**Repair Upfront Airbag Sensor Wiring
Harness Routing**

Campaign No. 2022070006, August 2022

Revision A 08/09/2022

SUBJECT: **Model GLS-Class (167 platform)**
Model Year 2020

Figure 2

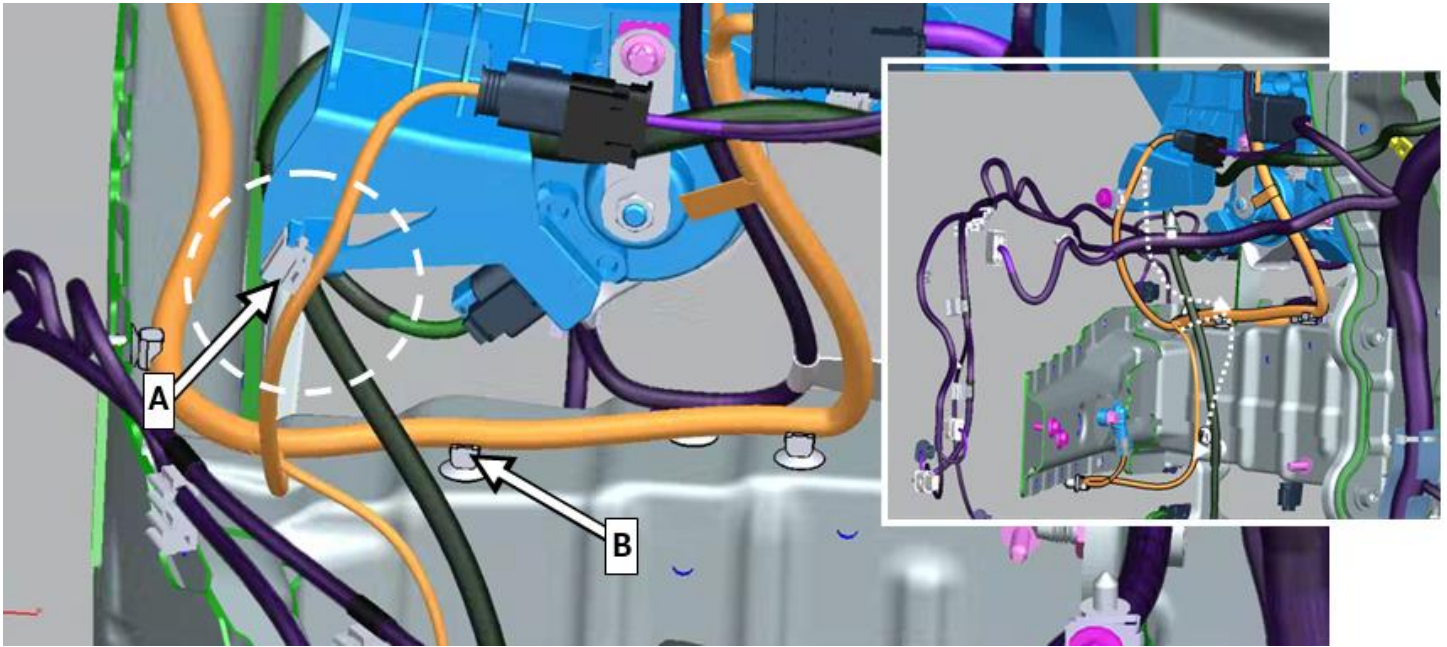
2. Remove bracket **(A, figure 2)** including cable tie from wiring harness and remove cable tie on bracket **(B, figure 2)** on upper left longitudinal member.

i Bracket **(A, figure 2)** will no longer be installed!

Figure 3

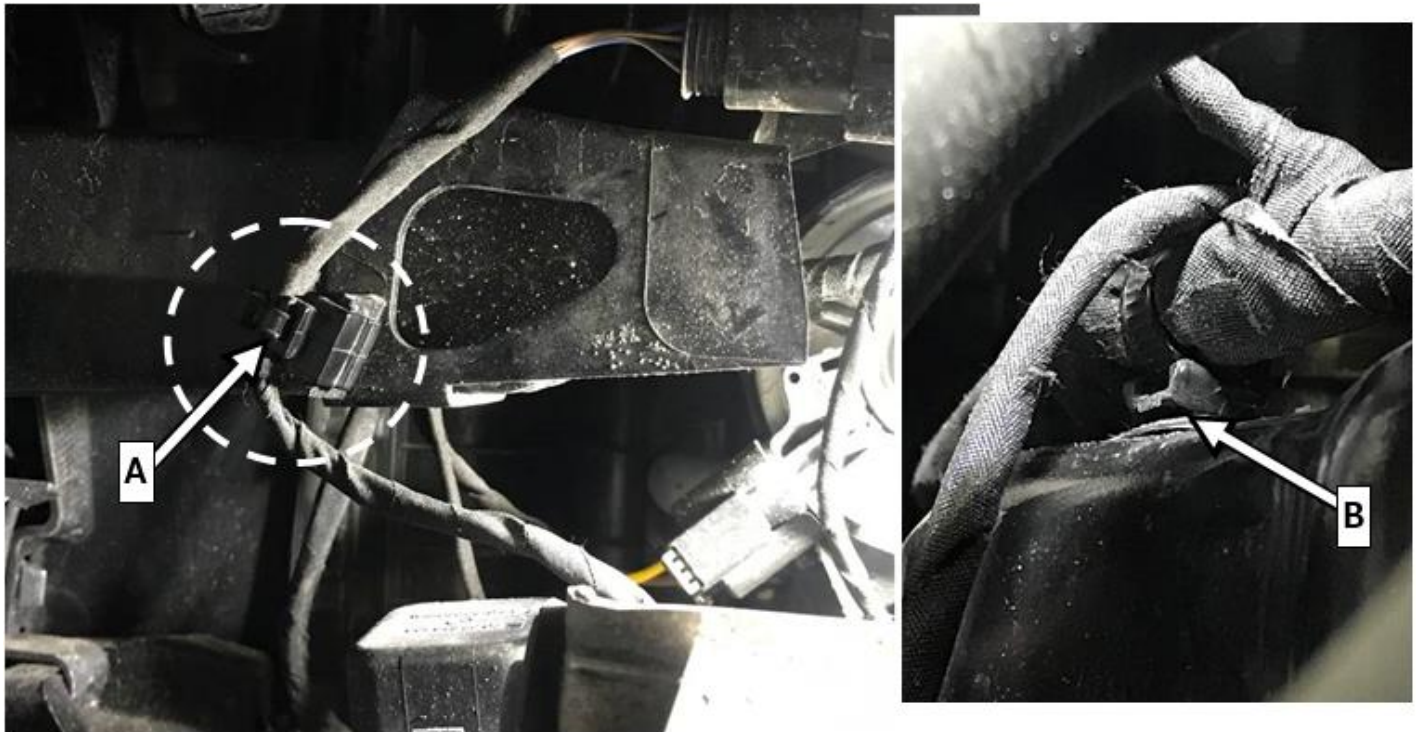
i **Figure 3** depicts the original brackets, cable ties, and wire routing for easier identification.

Figure 4

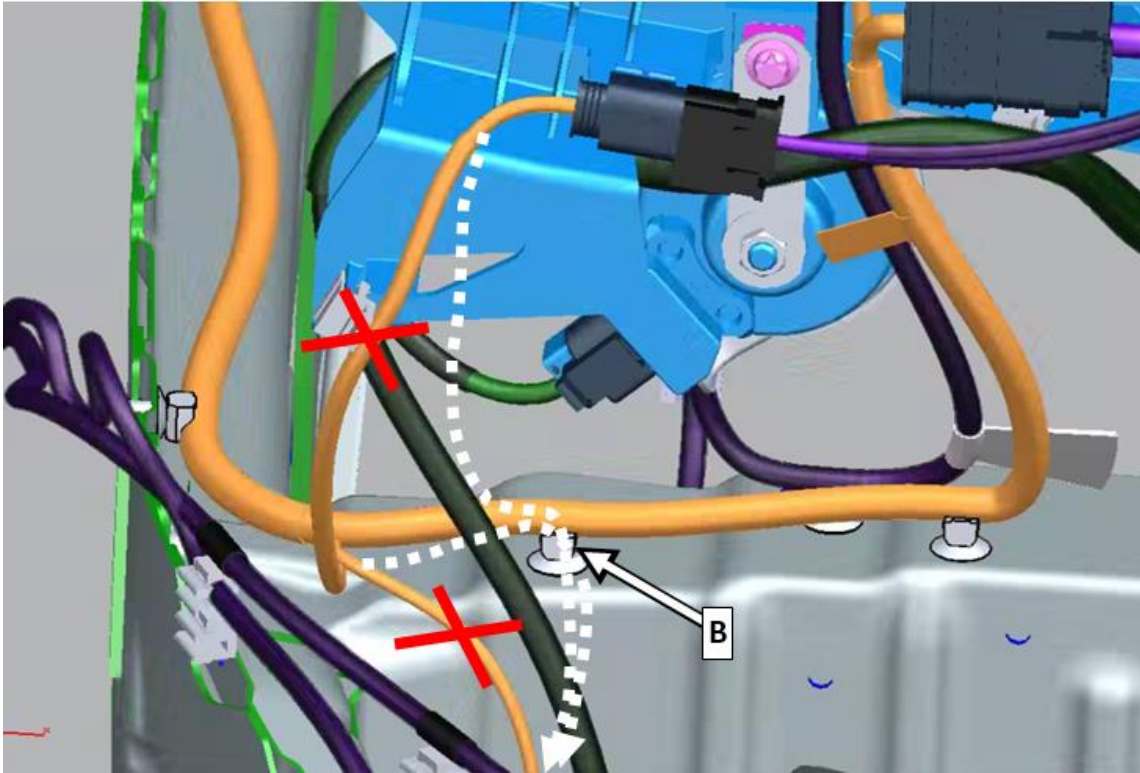
3. Route wiring harness according to **figure 4 and 5**. Fasten with new cable tie to bracket **(B, figure 4)**.
